Access Compliance Report

Public Rights-of-Way

Intersection ID: 43655	Main Street: HUNTINGTON_MEADOW_LN	Cross Street: KELLINGTON_CT	Location: SE
ADA ID: F402A31F7ECE	Ramp Type: Perp	Initial Pass/Fail: Fail	Overall Compliance: No
Severity Score: 25			
Codes/Mitigation Info/Possible Solution		Field Measurements/Component Compliance

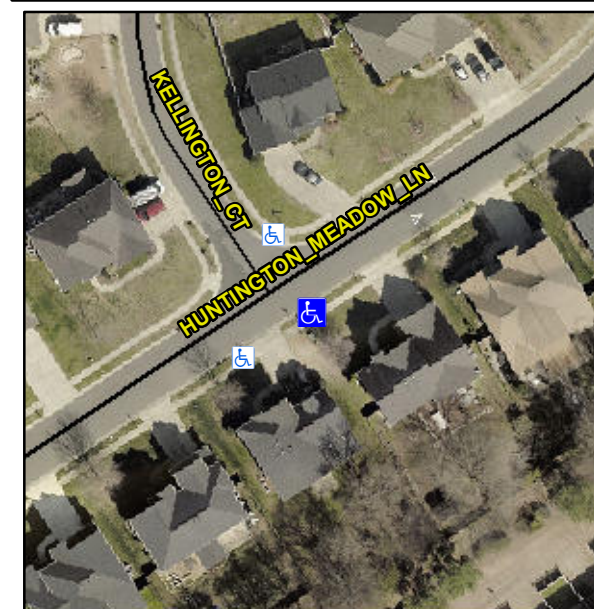
Not Found, R304.2.2

Compliance	Description	Data	Compliance	Description	Data
N/A	Ramp Length (in)	46.0	No	Ramp Slope (%)	12.7
Yes	Ramp Width (in)	54.0	Yes	Ramp XSlope (%)	1.1
N/A	Flare Type LT	N/A	N/A	Flare Type RT	N/A
N/A	Flare Slope LT (%)	N/A	N/A	Flare Slope RT (%)	N/A
N/A	Flare Traversable LT?	N/A	N/A	Flare Traversable RT?	N/A
N/A	Landing Length (in)	N/A	N/A	DWS Provided?	N/A
N/A	Landing Width (in)	N/A	N/A	DWS Contrast?	N/A
N/A	Landing Slope (%)	N/A	N/A	DWS Length (in)	N/A
N/A	Landing X Slope (%)	N/A	N/A	DWS Full Width?	N/A
N/A	Landing Curb? (Y/N)	N/A	N/A	DWS Offset (in)	N/A
N/A	Shared Landing?	N/A			
N/A	Gutter Ponding?	N/A	N/A	Gutter Slope (%)	N/A
N/A	Gutter Lip Ht (in)	N/A	N/A	Gutter X Slope (%)	N/A
N/A	Painted X Walk1?	No	N/A	Painted X Walk2?	N/A
	X Walk 1 Direction	To N		X Walk 2 Direction	N/A
N/A	X Walk 1 Width (in)	N/A	N/A	X Walk 2 Width (in)	N/A
	X Walk 1 Slope (%)	3.4		X Walk 2 Slope (%)	N/A
	X Walk 1 X Slope (%)	1.0		X Walk 2 X Slope (%)	N/A

Remove & Replace Entire Ramp.
